DELEGATED HOUSEHOLDER APPLICATION REPORT

App Ref: PL/25/0826

Address: 11 ARGYLE ROAD, READING, RG1 7YL

Proposals: Single storey rear and side extension following the demolition of existing garage and store + detached out building

Proposed Elevations Plan:

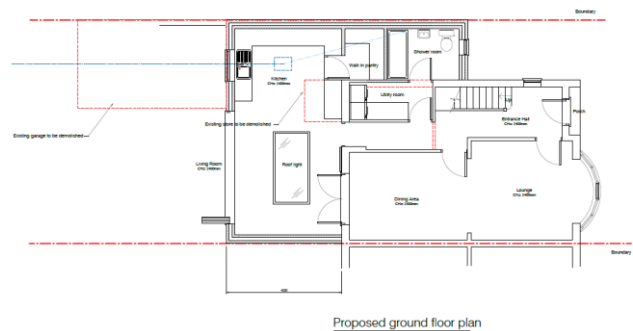
However, the host dwelling is characterised by a pitched roof form, and the Council's Design Guide to House Extensions SPD encourages extensions to reflect and complement the architectural characteristics of the original building where practicable. In this context, it is considered that a pitched roof would provide a more sympathetic design response and would better relate to the proportions and roof form of the host dwelling.

This matter was raised with the applicant's agent during the course of the application. The agent advised that a pitched roof, either as a mono-pitch or a side-to-side pitch forming a gable, was not pursued on the basis that matching clay roof tiles would not perform adequately at a shallow pitch. This explanation has been noted; however, it is not considered to be a compelling design justification, as alternative design solutions and materials could be explored to achieve a pitched form that accords with the guidance set out within the SPD.

Notwithstanding the above and acknowledging that flat roofs are prevalent in the area, the flat roof design is not, in itself, considered to result in such significant harm to the character or appearance of the dwelling or the wider area. Accordingly, while a pitched roof would be preferable and more consistent with the SPD, the design of the proposed extension does not form a determinative reason for refusal.

With regard to No. 9 Argyle Road, the adjoining semi-detached property, the extension would be located immediately adjacent the common boundary, would project approximately 4 metres from the rear elevation and would have a maximum height of approximately 3 metres. The extension would clearly be visible to neighbouring occupiers and would appear to breach a 45 degree line to nearest habitable room window. It is recognised that the roof would be flat to minimise the impact. However, the depth and height, located immediately on the boundary combined with the change in site levels is considered to result in an overbearing effect.

height, due to its extension directly on the boundary, combined with its depth, height and the elevated nature of the site, it would result in a noticeable sense of enclosure when experienced from No. 13.

The extension would be located in close proximity to the side elevation and habitable room windows of No. 13, including the dining room window referenced in the neighbour's representation. As a result, the development would appear overbearing and would materially harm the outlook enjoyed by the occupants of that property.

Proposed Outbuilding Elevations and Floor Plan:

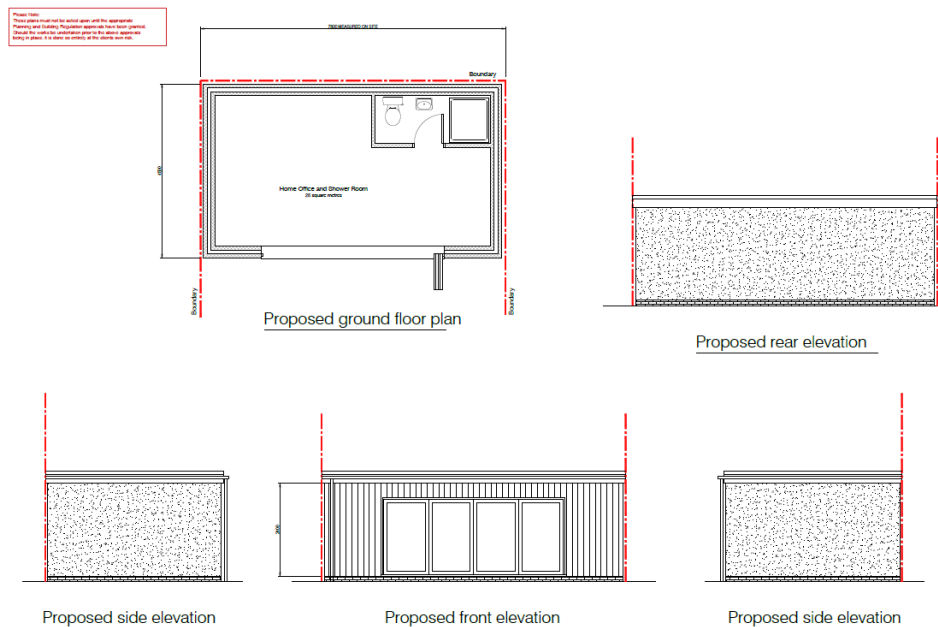
The proposed detached outbuilding is shown to fall within the Root Protection Areas (RPAs) of several retained trees, including T2 (Yew), T3 (Sycamore), T5 (Holly) and T7. The submitted drawings do not clearly specify the proposed foundation type, and there is inconsistency between the AIA and the architectural drawings regarding whether the outbuilding would be constructed using a concrete slab. As such, it has not been demonstrated that excavation within RPAs would be avoided or minimised.

In addition, no Tree Protection Plan has been submitted to demonstrate how retained trees would be safeguarded during demolition and construction works. The proposal includes a shower room within the outbuilding; however, service routes have not been plotted or assessed as part of the AIA. There is also insufficient information regarding changes in ground levels, access paths, landscaping proposals and how no-dig construction techniques would be implemented within RPAs.

The proposed detached outbuilding would be sited within the rear garden and would remain visually subservient to the main dwelling. Its scale, flat roof form (acknowledging design matters above) and domestic appearance would ensure that it would not appear unduly prominent or out of keeping within the garden setting. There are other outbuildings of similar scale in the wider area. Overall, the scale, massing and design of the proposed development would be compatible with the character of the host property and the surrounding residential area.

The proposed outbuilding would be sited to the end of the garden and not considered to result in any material overbearing effects.
